January 29, 2003
BVY 03-13

Subject: Vermont Yankee Nuclear Power Station
License No. DPR-28 (Docket No. 50-271)
Vermont Yankee Emergency Plan Implementing Procedure Changes – Change #213

To: E-Plan Implementing Procedure Controlled Set Holders
From: Technical Support - DCC - Ann M. Pichette
Date: 01/29/2003
Re: VY EPlan Implementing Procedure Change #213, Instruction Sheet

FIGURE 5
OPERATIONS SUPPORT CENTER - COMMUNICATIONS ARRANGEMENT

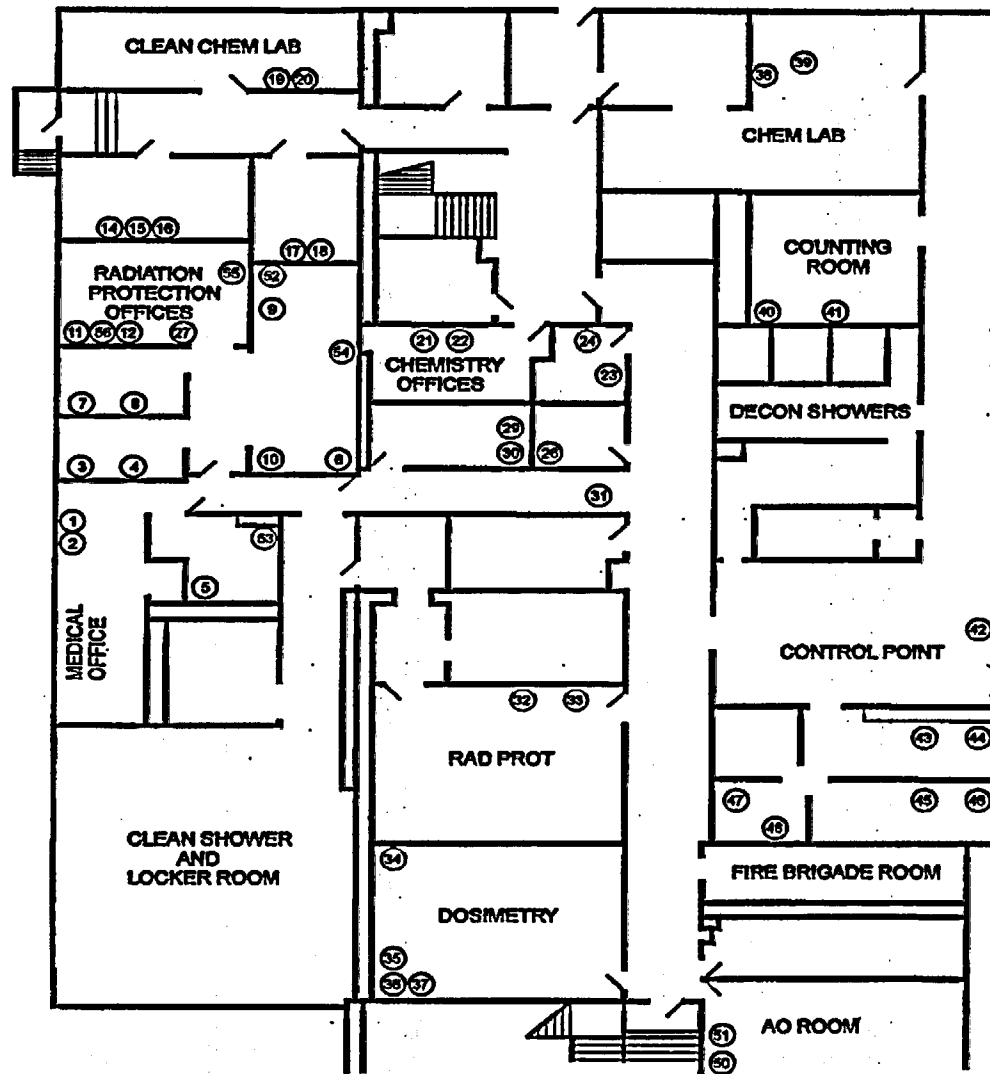
*All areas retain same functionality.
Figure 5 - payphone (#49) deleted - no E-Plan function.*

FIGURE 6
EMERGENCY OPERATIONS FACILITY/RECOVERY CENTER - COMMUNICATIONS ARRANGEMENT

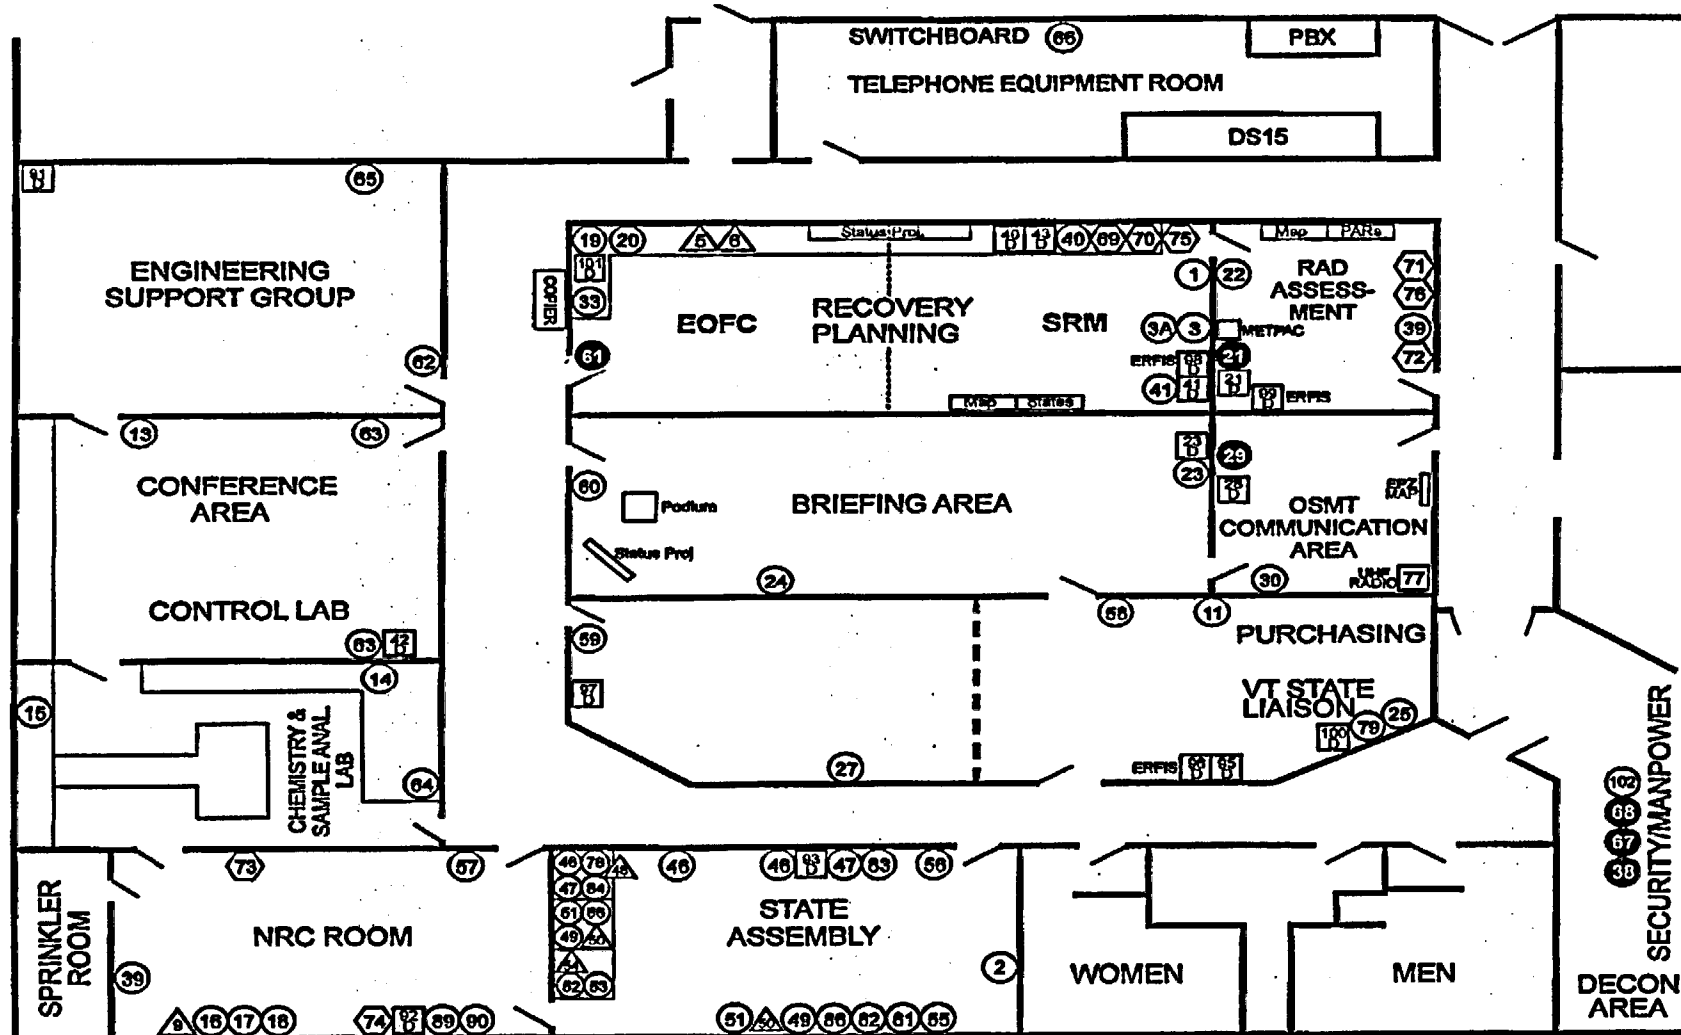
The changes to the EOF floorplan is an improvement within the facility. The SRM's office which was previously overcrowded will now have adequate space to allow personnel to communicate and function more effectively. The Engineering Group will have a larger room with the necessary equipment to perform their duties. The OSC area change eliminated the lunch room and moved the AO room into that vacancy. This change does not affect the operation of the facility. Neither of these changes decreases the effectiveness of the EPlan and continues to meet the requirements.

FIGURE 3
EOF/RC LAYOUT

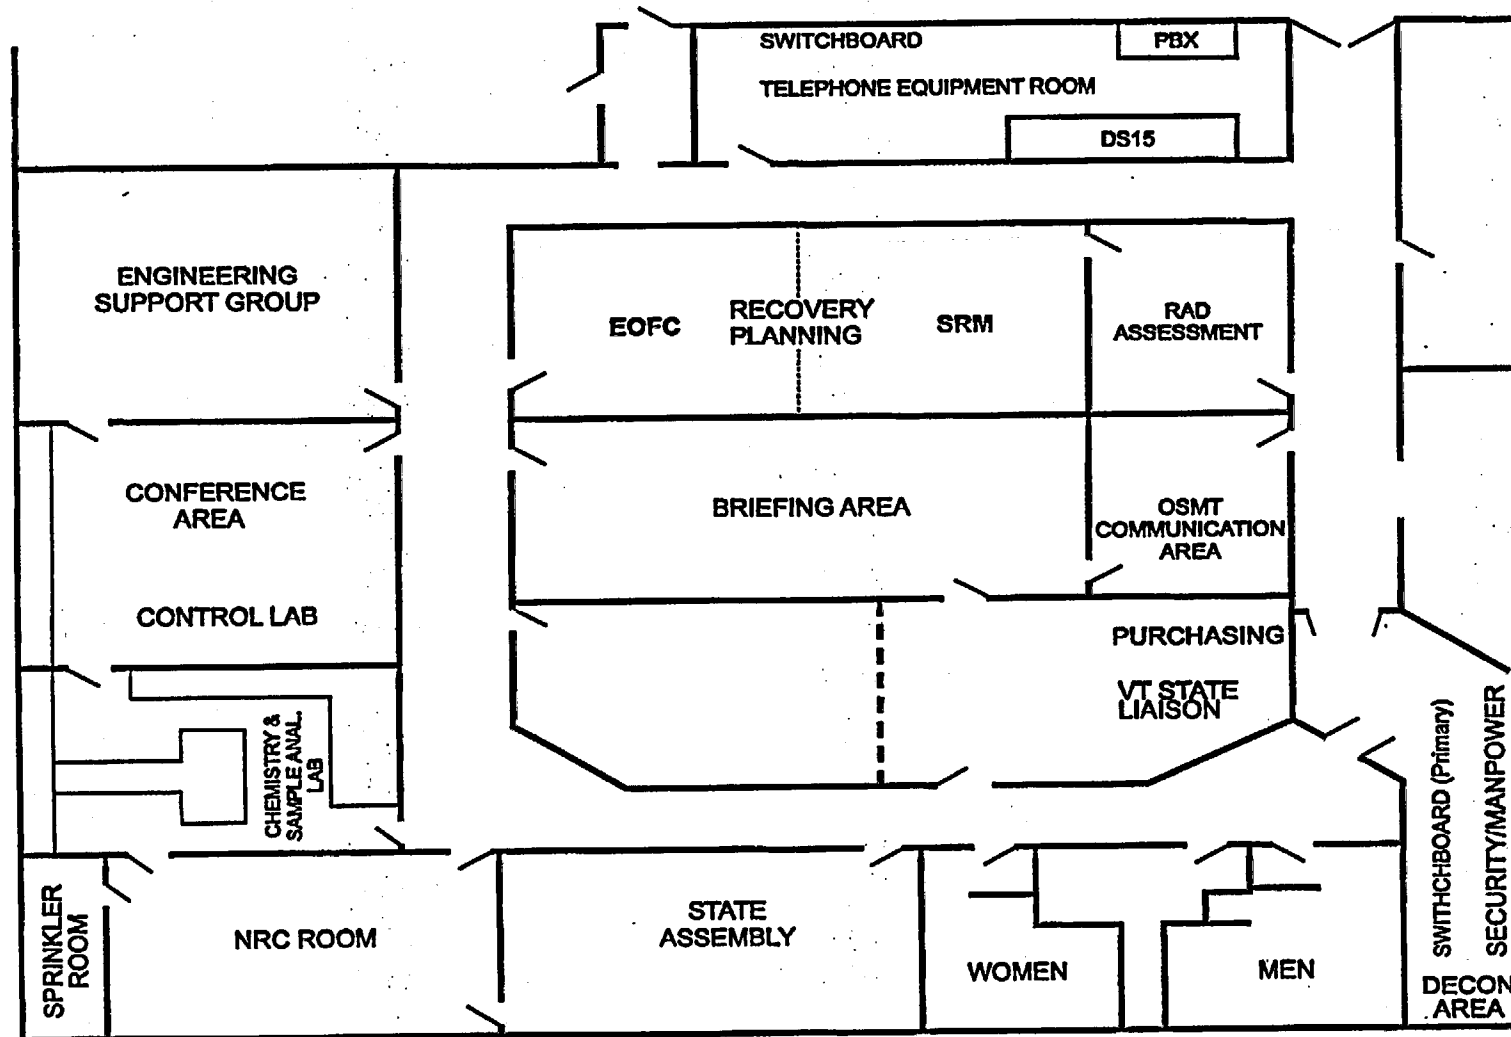
Reorganization of the EOF floorplan to facilitate communication and enhance interaction. The old SRM area was overcrowded and remote from the Rad Assessment area. The new layout provides more room for staff and moves the assessment area adjacent to the SRM area. All of the same communication and computer capabilities are retained the new layout also reduces activation time since the Recovery Planning area is the only room needing setup.
